SUBJECT: High School Expansion Project – Deferred Maintenance
NB Kenney Change Order No. 3 (FY 21)

Field Bulletin 004

RFI-008 – Rooms 123, 126 Unit Clarifications

Project: Brookline High School Expansion Project
Project F
Brookline, MA 02445
WRA Project #: 21706

M2-02-F

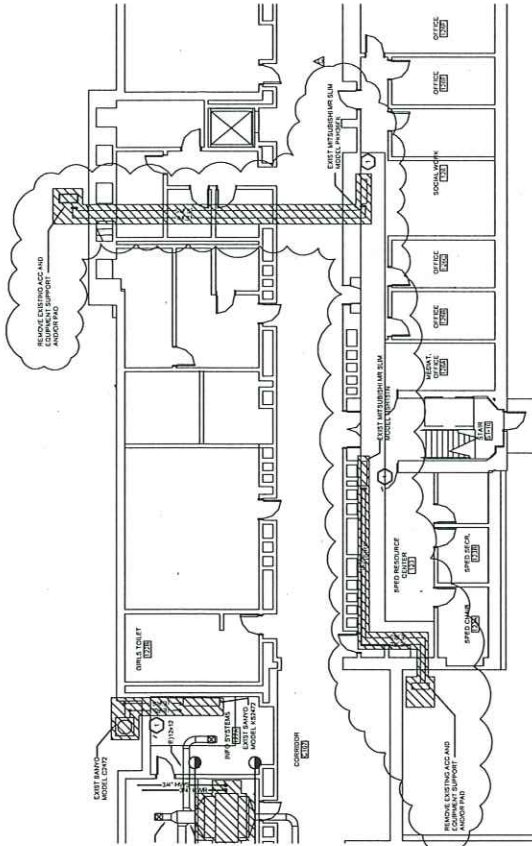
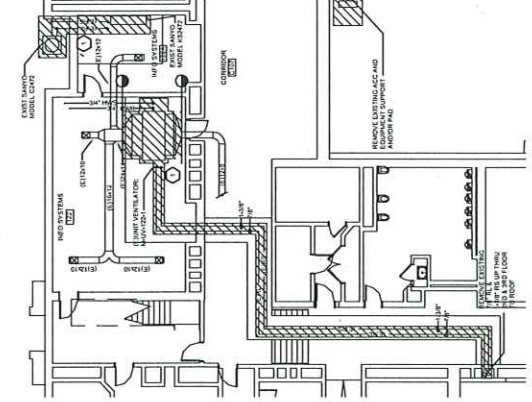
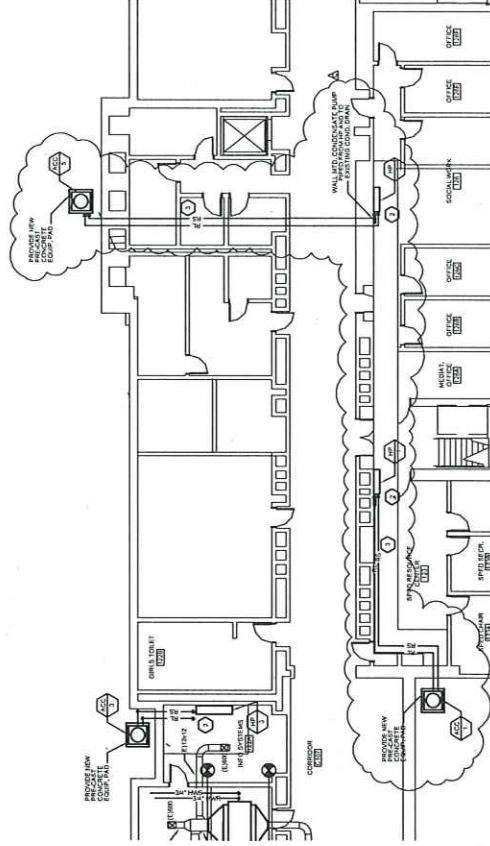
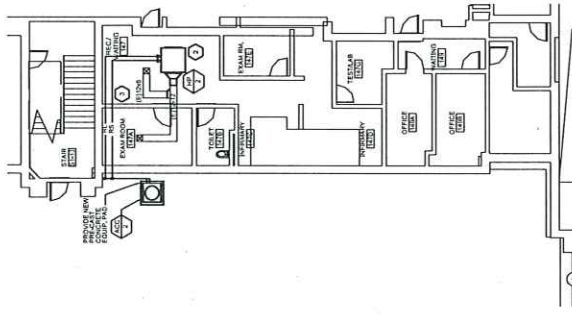
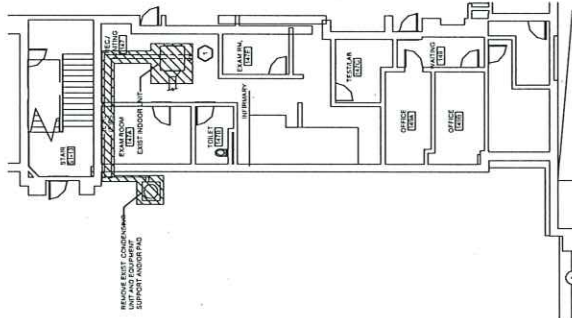
Costs associated with adding an additional Heat Pump in Room 126 as outlined in Bulletin # 4

- Please provide pricing for the removal and replacement of an existing wall-mounted heat pump in Room 126 of the Main High School and associated exterior pad-mounted ACC unit. Submit pricing for review with the Town of Brookline prior to proceeding with the additional work.
